Our Ref: 101903

Re: Howlong Sand and Gravel Quarry (SSD 8804) – Request for Additional Information

Figure A Updated Figure 1-1 of Water Technology (2021a) - 1% AEP flood difference map and upstream model boundary

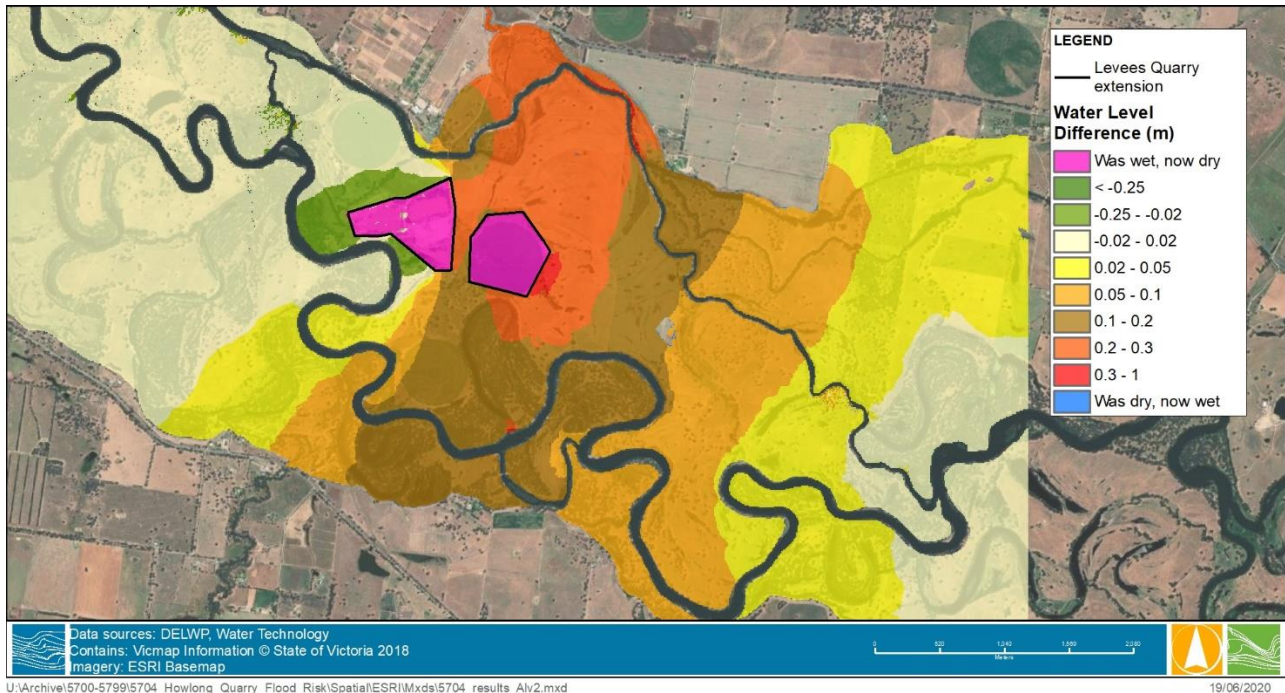
- a) *Figure 1-1, move the legend to the right-hand side, to allow a clear view of the pits and river.*

An update to Figure 1-1 of the *Review of Flood Modelling Outcomes* prepared by Water Technology (2021) is presented as **Figure A**. This figure focuses on flood modelling upstream of the Quarry Site in response to the Council submission and the meeting held with Council on 9 June 2020. It is noted that the Council submission discussed upstream and downstream risks to infrastructure, particularly the Riverina Highway.
